UNITED STATES PATENT AND TRADEMARK OFFICE

APPLICATION NO.	FILING DATE	FIRST NAMED INVENTOR	ATTORNEY DOCKET NO.	CONFIRMATION NO.
10/710,787	08/03/2004	Alexander Stoll	81101892 / FMC 1771 PUS	4786

Office Action Summary	Application No. 10/710,787	Applicant(s) STOLL ET AL.	
	Examiner Dana Ross	Art Unit 3722

DETAILED ACTION

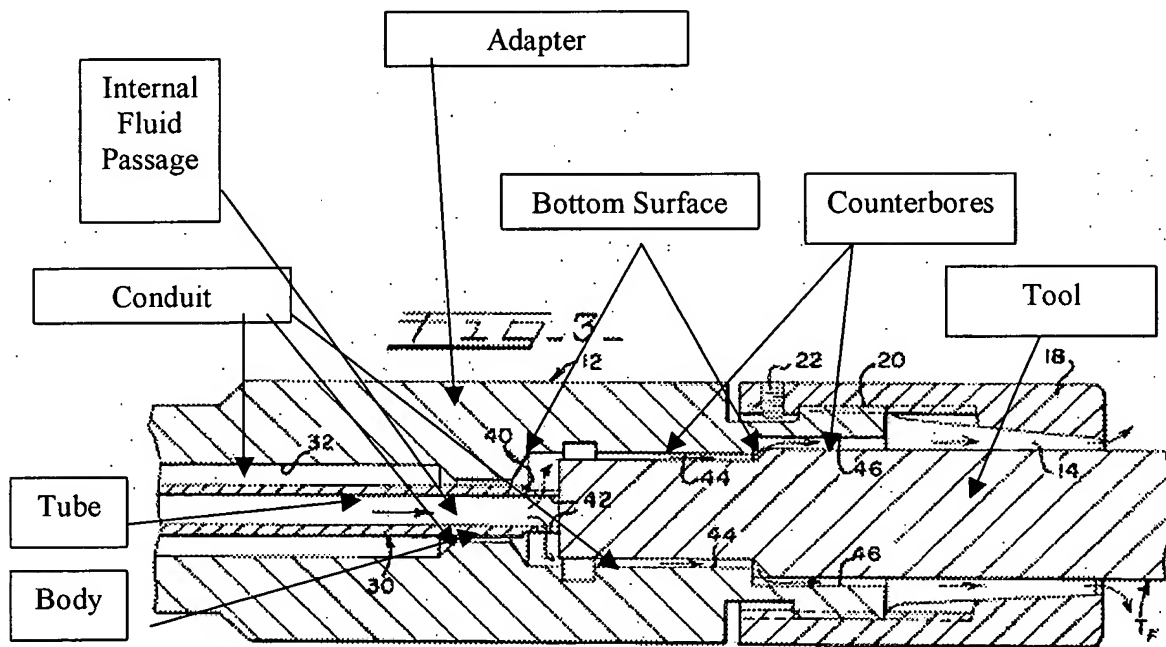
‘654 teaches a tool holder for coolant deliver with a plurality of bores and a bottom surface, a conduit with first and second diameters and internal fluid passage (see figure 3 below) and spring 34 (see figure 2); the connection tube with a section with a smaller outside diameter than another section of the tube (see figure 3 below) with the inside of the tube engaging with the

internal fluid passage. It is noted that '652 teaches a chamfer on a flange portion (see figure 1, for example).

Regarding the spring, '652 teaches spring 34 meets which the limitation requirements of claims 5 and 8 in that the tool receiving portion the end portion (see area 26 of figure 2) which places the spring 34 between the "tool receiving portion" and the "bottom surface" (see figures 2 and 3).

Regarding the chamfer, '652 teaches a chamfered area of the internal fluid passage (see figure 2 near reference number 36).
